# UNITED STATES PATENT AND TRADEMARK OFFICE

APPLICATION NO.	FILING DATE	FIRST NAMED INVENTOR	ATTORNEY DOCKET NO.	CONFIRMATION NO.
10/076,025	02/13/2002	Andre Larsen	NN-6259.200 US	7371
26137	7590	11/28/2003	EXAMINER	
PATENT DEPARTMENT SKADDEN, ARPS, SLATE, MEAGHER & FLOM LLP FOUR TIMES SQUARE NEW YORK, NY 10036			MENDEZ, MANUEL A	
ART UNIT		PAPER NUMBER		
3763				
DATE MAILED: 11/28/2003

<b>Office Action Summary</b>	Application No.	Applicant(s)
	10/076,025	LARSEN ET AL.
Examiner	Art Unit	
Manuel Mendez	3763.	. w.

## DETAILED ACTION

**FIG. 2**

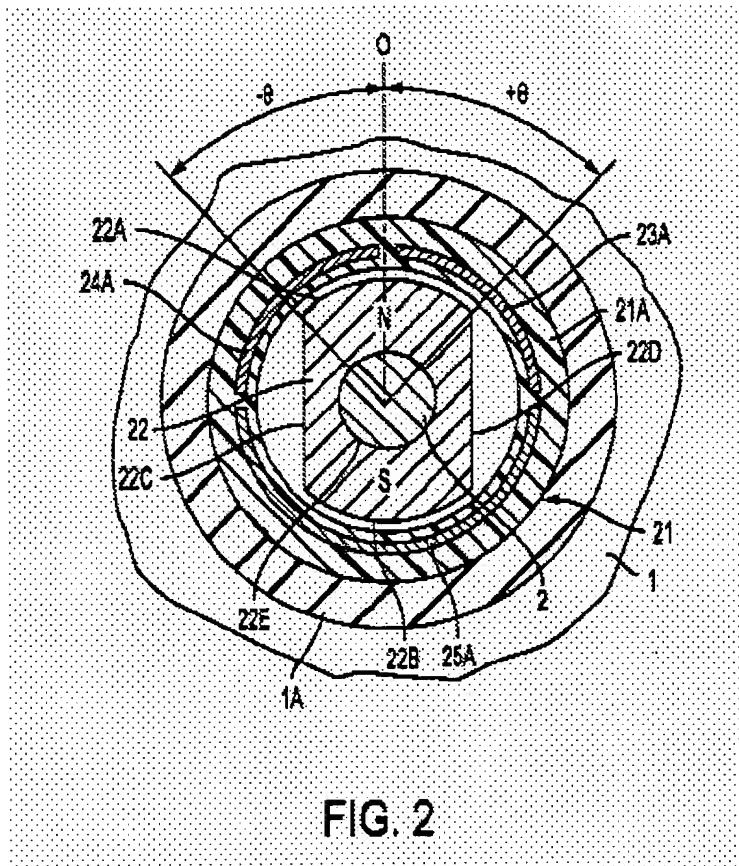
Claims 10-15 are rejected under 35 U.S.C. 103(a) as being unpatentable over **Groshong, et al., Gray, and/or Barton, et al.** in view of **Kogure, et al.** Neither **Groshong, et al., Gray, nor Barton, et al.**, disclose a magnet having the shape of a magnet ring. However, designing a magnet with the shape of a ring is conventional as evidenced by the teachings of **Kogure, et al.**

In figure 2, the Kogure, et al. Patent shows a magnet (22) having a ring shape. Based on the conventionality of ring-shaped magnets, for a person of ordinary skill in the art, such use in any infusion system would have been considered an obvious design alternative.
